Work Order ID 126303

Item ID: D3463-1 Accept ***N900040100*** Setup Start ***NS1***
 Revision ID: Stop ***NS2***
 Item Name: Arm
 Start Date: 11/4/2014 Start Qty: 8.00 ***8*** Cust Item ID:
 Required Date: 11/4/2014 Req'd Qty: 8.00 ***8*** Customer:
 Reference:

DESIGN RF	DRAWN BY RF	DART AEROSPACE LTD HAWKESBURY, ONTARIO, CANADA	
CHECKED #	APPROVED #	DRAWING NO. D3463	REV. B SHEET 1 OF 4
DATE 05.12.05	TITLE STEP WELDMENT		SCALE 1:8
A	05.09.20	NEW ISSUE	
B	05.12.05	REVISE DIM.; D3463-5 WAS D3463-5F

D3463-1 ARM

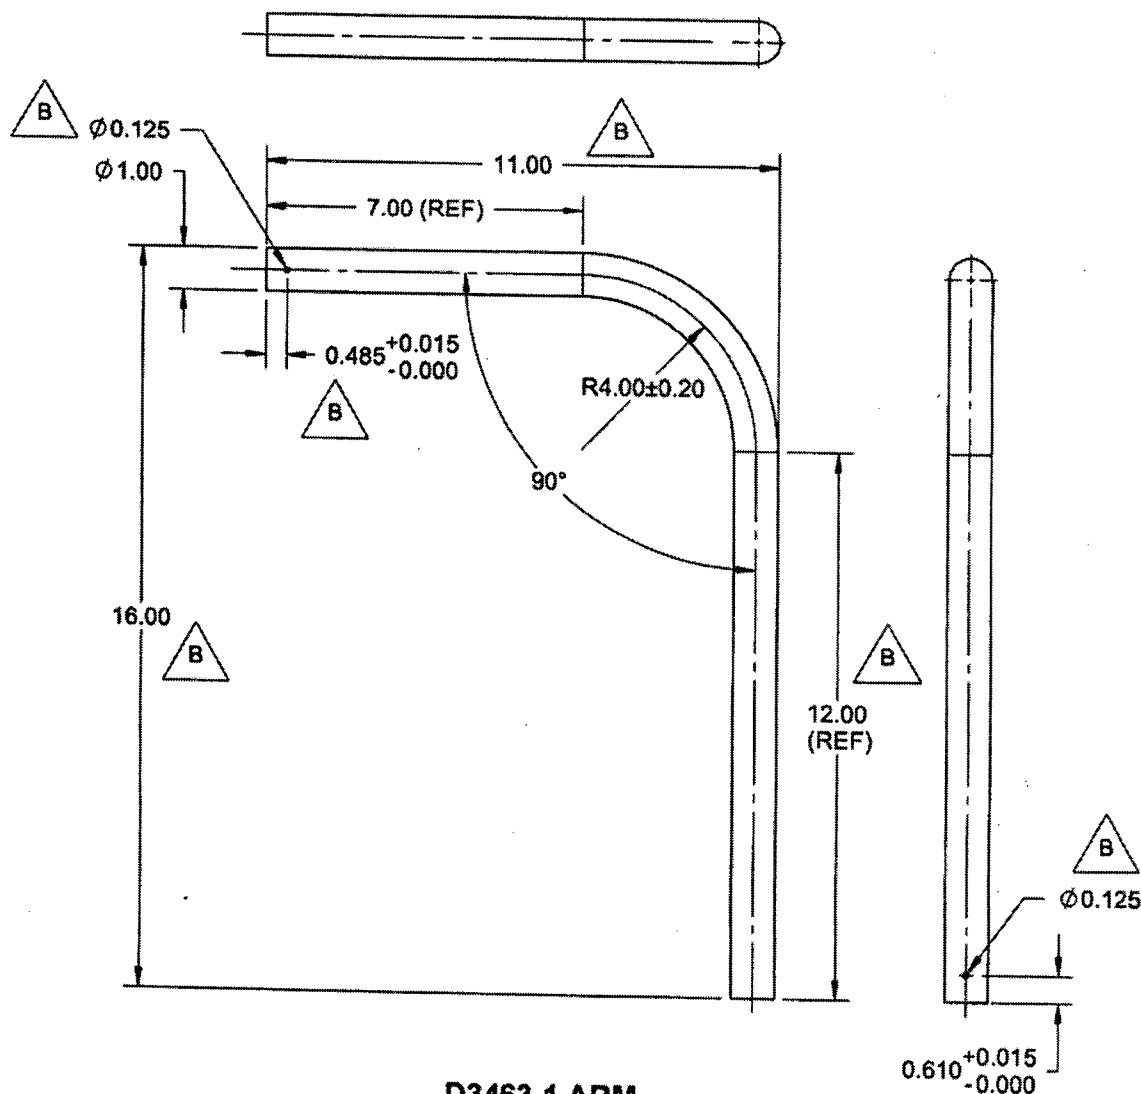
Root Cause	Date	Step	Qty	Description of work order update or non-conformance	Initial Chief Eng	Action Description	Sign & Date	Verification	QC Inspector
Design	15/07/13	130	2	0.485 on Ø 0.125 hole is 0.615, no second check	A.P.	SCRAP, 05453-S PLUG WILL BOTTOM OUT BEFORE HOLES LINE UP.	J.C.L. 15/07/13		
Doc/Data					15.07.16	REPLACE PART			
Equip/Tooling									
Handling/Pre									
Material									
Operator									
Offset/Setup									
Process									
Supplier									
Training									
Transport									
Unapproved
